Appl. No. 10/774,326
Amdt. Dated December 11, 2006
Reply to Office Action of July 12, 2006

Amendments to the Drawings:

REMARKS

FIG. 2

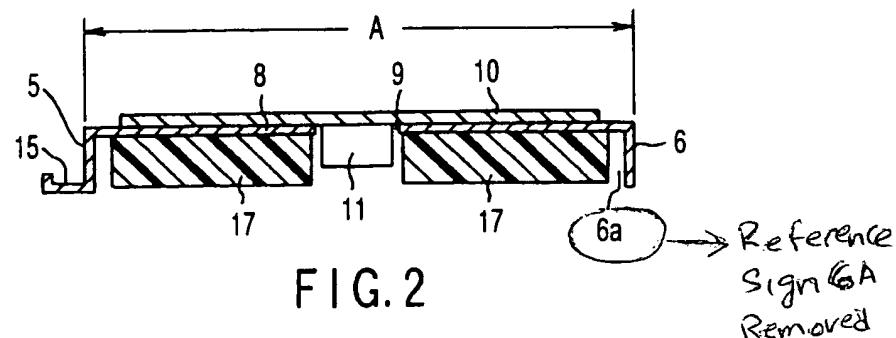
The attached sheet of drawings includes changes to FIG. 2 to delete reference sign 6a, replacing the original FIG. 2 sheet.

On page 2 of the Action, the drawings were objected to under 37 CFR 1.84(p)(5). In response, FIG. 2 has been amended to address the above objection. Reconsideration and withdrawal of the objection are respectfully requested.
